MVTX Production Readiness Review Overview

MVTX Production Readiness Review (Remote Meeting)

12/15/2020

1-piece Al End-Wheel

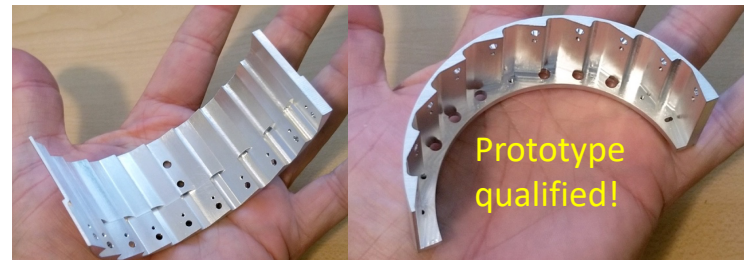
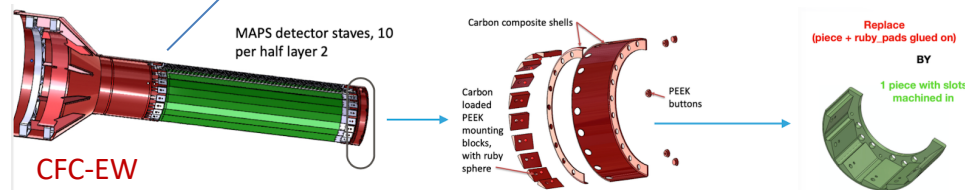
2 design changes:

- End-Wheels: a simple 1-piece design, made of Al, ~\$10K/pair
- Lock-and-roll (nose roller) system on the nose of detector to protect against crushing into the Beam Pipe

Are the changes still consistent with the Requirements?

Yes ([link to the EW discussions](#))
